Mtg Date: February 28, 2019
To: Planning Commission
From: Julie Johnston, AICP
Subject: AMENDED Advia Credit Union Site Plan

New Headquarters Facility for:
Advia Credit Union
6400 WEST MAIN ST. · KALAMAZOO, MI 49009

SITE PLAN
1"=50'-0"

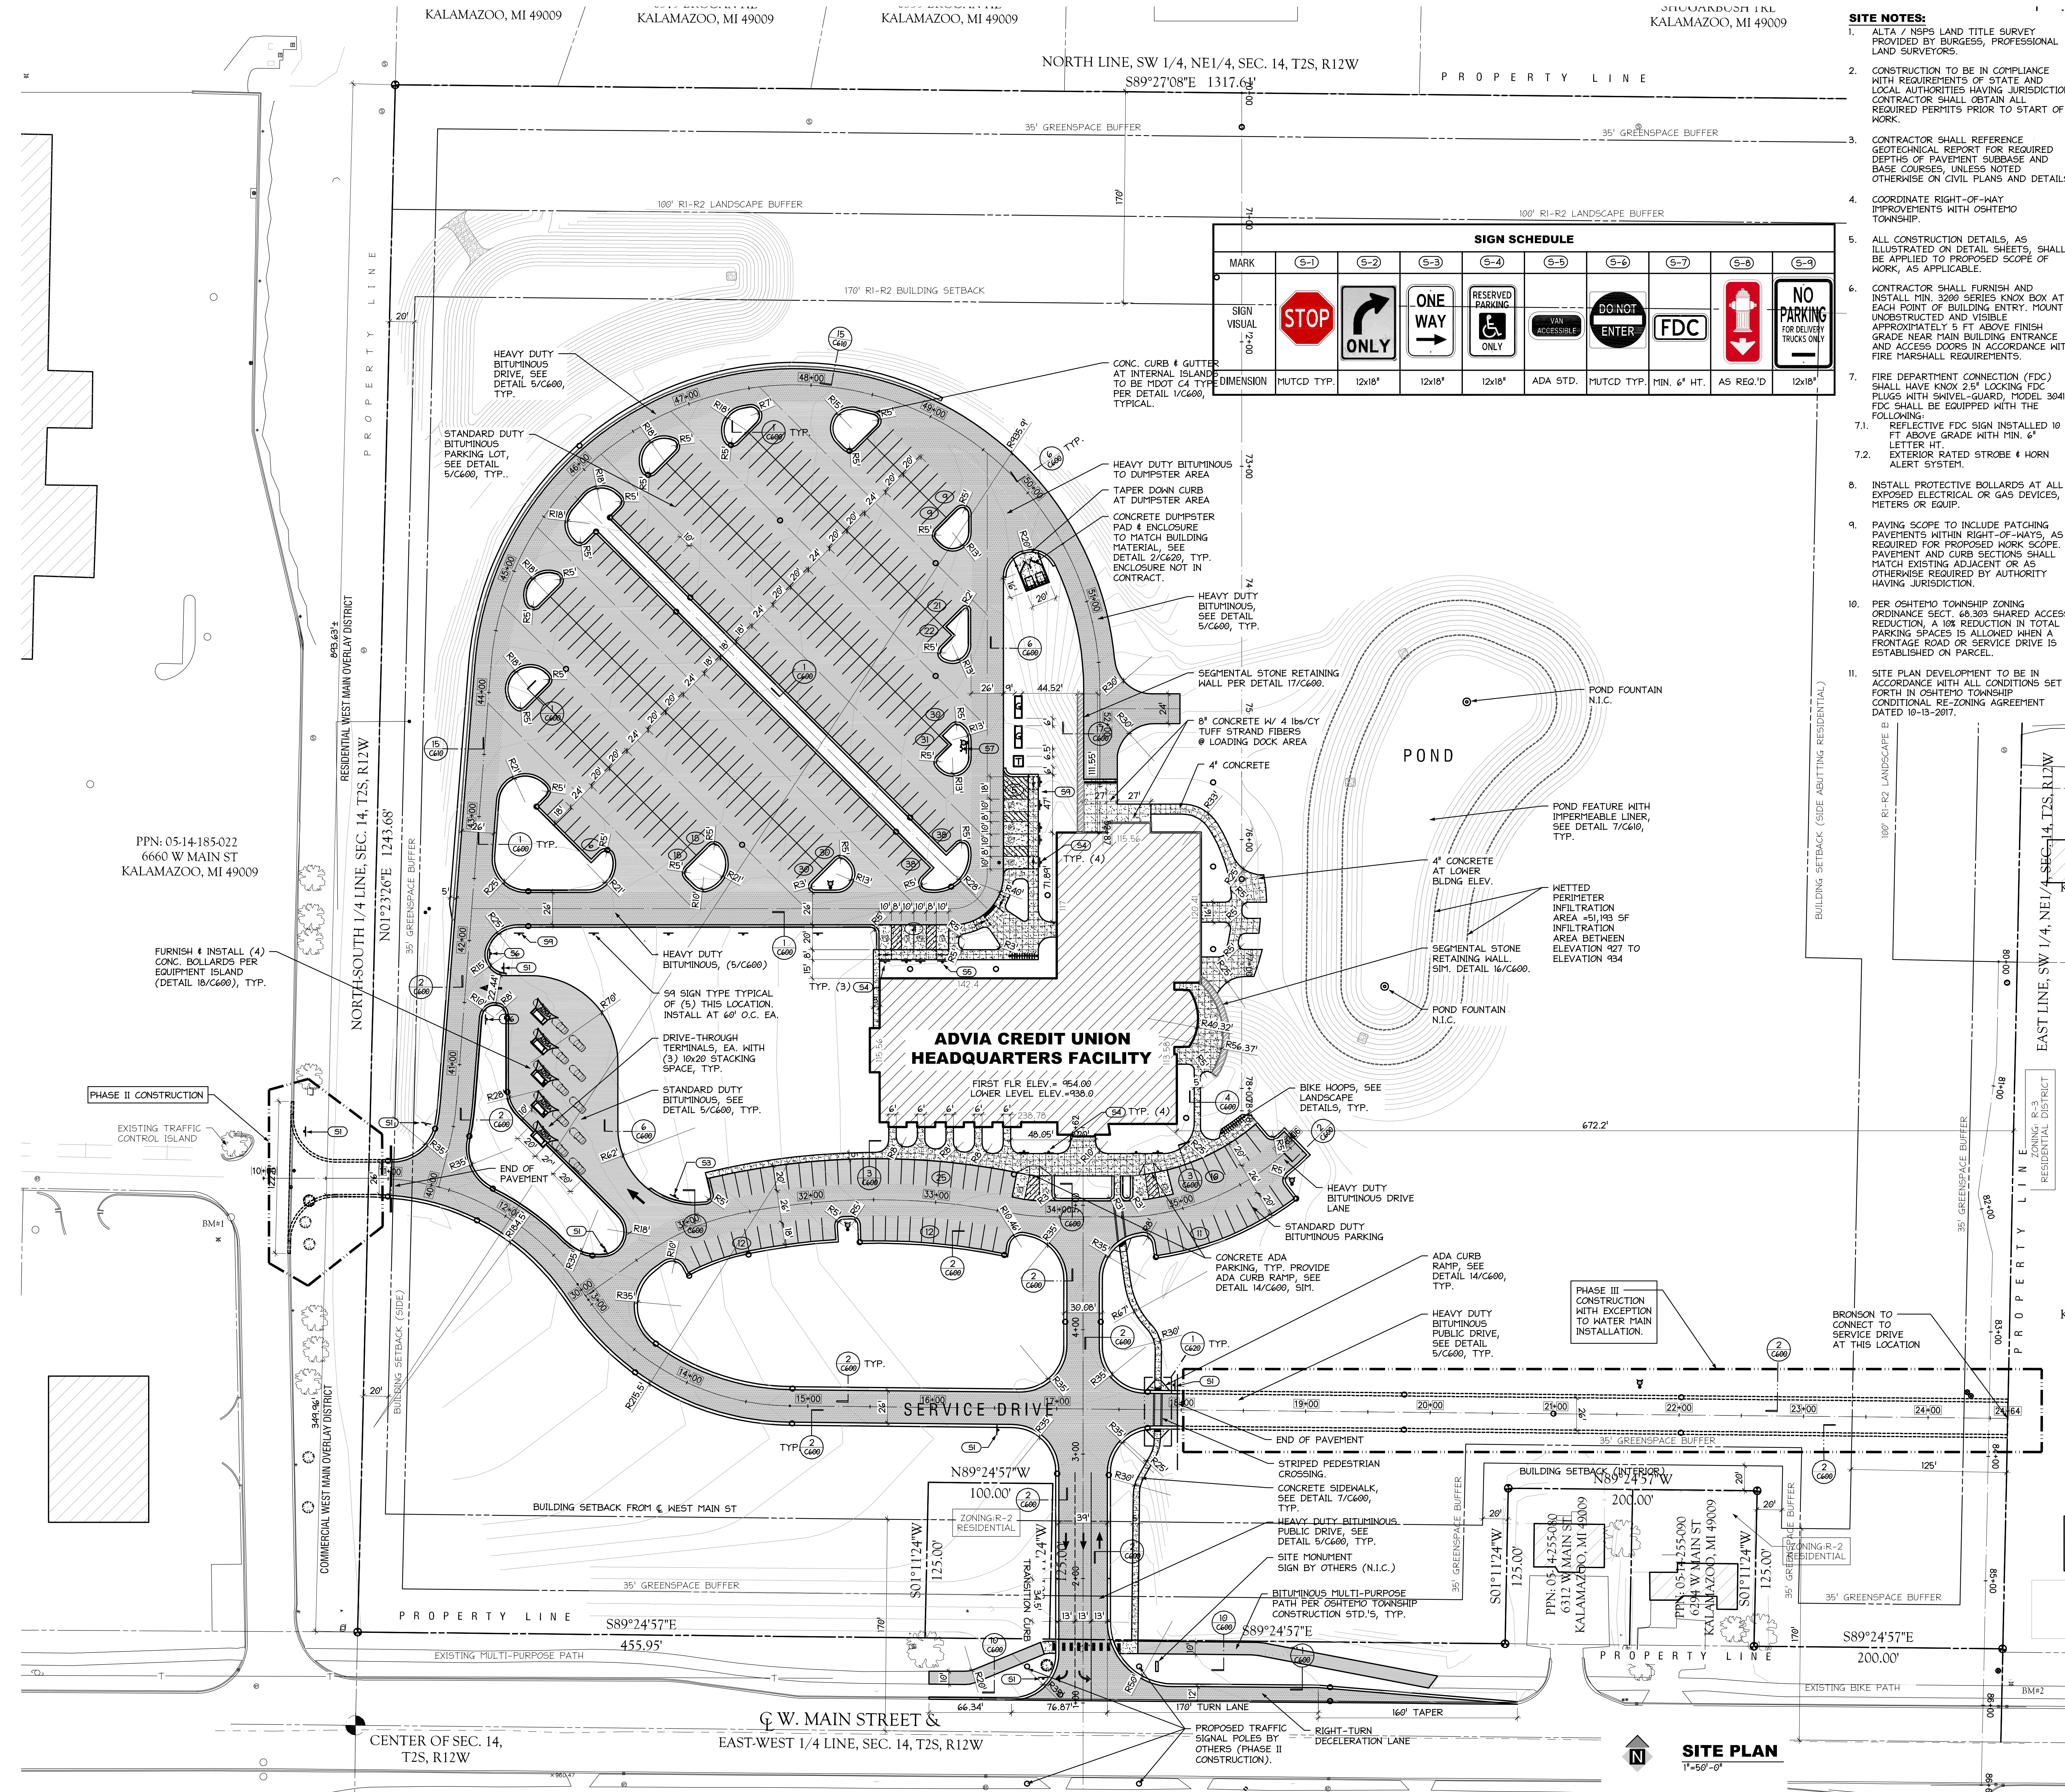
- **Staff is recommending the dashed line that outlines the western nonmotorized path on the site plan be removed and the nonmotorized network be displayed on the landscape plan. In addition, the path should extend to the western property line.**

5. The site plan indicates the intersection light poles to be installed “by others.” The installation of the intersection light is a condition of the rezoning and therefore must be included with this development. The language “by others” should be removed from the plan prior to issuance of a building permit.

7. The restricted curb cut for the east Meijer drive should be shown on the site plan and included as part of Phase II prior to the issuance of a building permit.

8. A proposed public sanitary sewer easement shall be provided on the site plan along the eastern property line prior to the issuance of a building permit.

9. The site plan indicates a 35-foot landscape buffer along the east property line adjacent to the Bronson property. This is incorrect. A 10-foot landscape buffer is required here. This buffer is shown correctly on the landscape plan, but needs to be revised on the site plan, which should be provided to the Township prior to the issuance of a building permit.

This request has been completed.

GRADING PLAN
1"=50'-0"

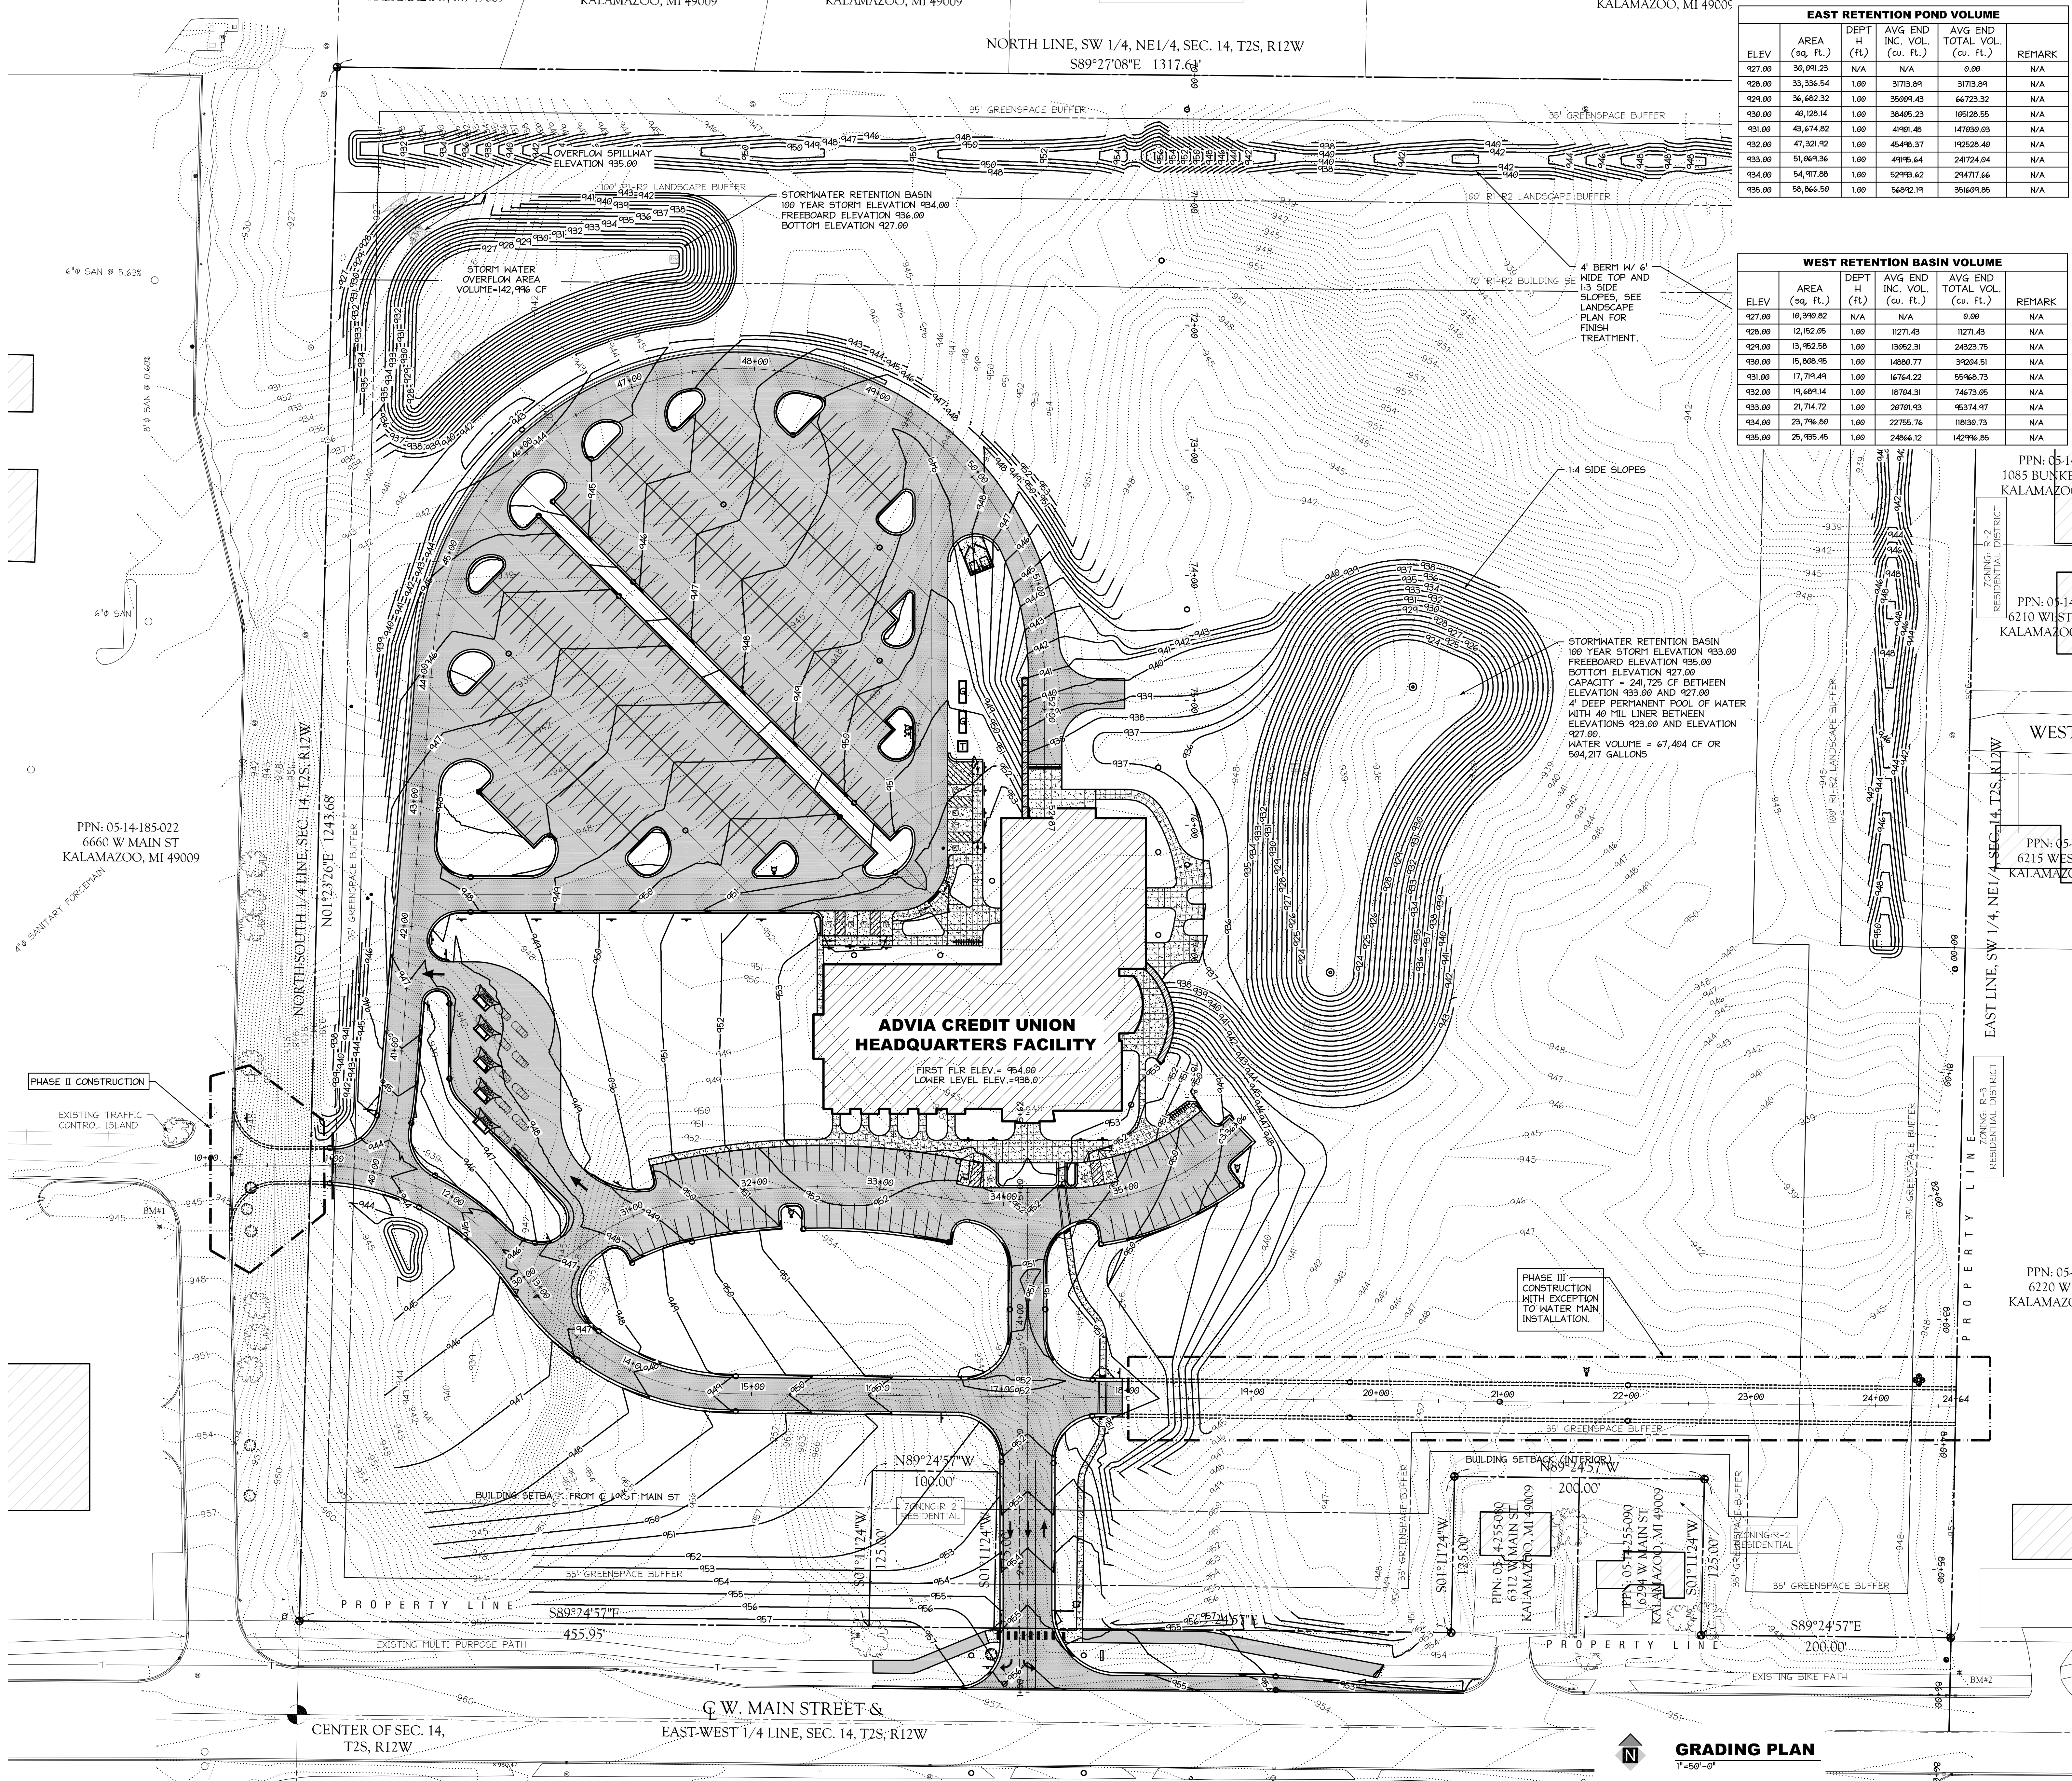
- **The Planning Commission will need to determine if the undulating berm required by the conditional rezoning is met through the topography of the site or must be installed as part of the 100-foot buffer.**

10. The retention pond tables on the grading plan obscure the berm graphic in the northeast corner of the property. Provide an updated grading plan prior to the issuance of a building permit with these tables moved so the full berm can be visualized.

The applicant has now placed a berm within the 100-foot buffer adjacent to the residentially zoned properties. The grading detail of the berm is found on Sheet C300: Grading Plan. A note is shown on the plan indicating the berm is four feet high and six feet wide at the top. The four-foot height undulates with the existing topography of the site. Some of the berm detail is obscured by retention tables on the plan. We would request the applicant move these tables so the full detail of the berm can be shown. Staff is satisfied the berm meets the requirements of the conditional rezoning.
